# UNITED STATES PATENT AND TRADEMARK OFFICE

APPLICATION NO.	FILING DATE	FIRST NAMED INVENTOR	ATTORNEY DOCKET NO.	CONFIRMATION NO.
10/590,581	06/15/2007	Lindsay K. Newcombe	105MC-036	8703
32192	7590	11/12/2008		
BRADLEY N. RUBEN 503 MITCHELL COURT CHAMPAIGN, IL 61821-3535			EXAMINER BOOTH, MICHAEL JOHN	
			ART UNIT 4158	PAPER NUMBER
			MAIL DATE 11/12/2008	DELIVERY MODE PAPER

<b>Office Action Summary</b>	<b>Application No.</b> 10/590,581	<b>Applicant(s)</b> NEWCOMBE ET AL.	
	<b>Examiner</b> MICHAEL J. BOOTH	<b>Art Unit</b> 4158

## **DETAILED ACTION**

FIG. 2

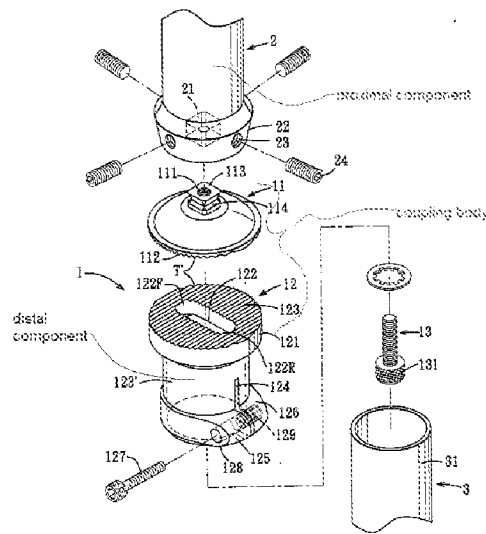
Chen discloses an apparatus for attaching a prosthetic limb to the bone of a patient to failsafe if excess force is applied to the limb, comprising a proximal and distal component to mount to the limb and a coupling body coupling together these components with freedom to articulate when excess force is applied. (Fig. 2).

Chen discloses a clutch-like mechanism having opposing sets of co-operating clutch teeth (112 & 123) where the teeth are symmetrical and the clutch-like mechanism may disengage with rotational direction of torque applied to the limb. (Fig. 2).

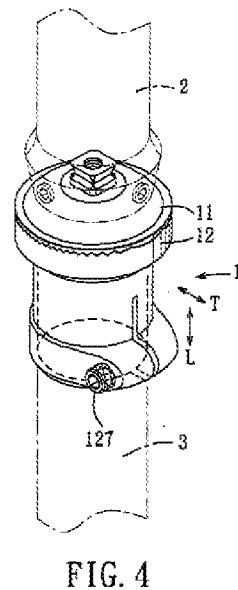
Chen discloses an apparatus incorporated into the bone implant component on a prosthetic limb. (Fig. 2). The prosthetic limb connecting to the distal component shown in figure 2.
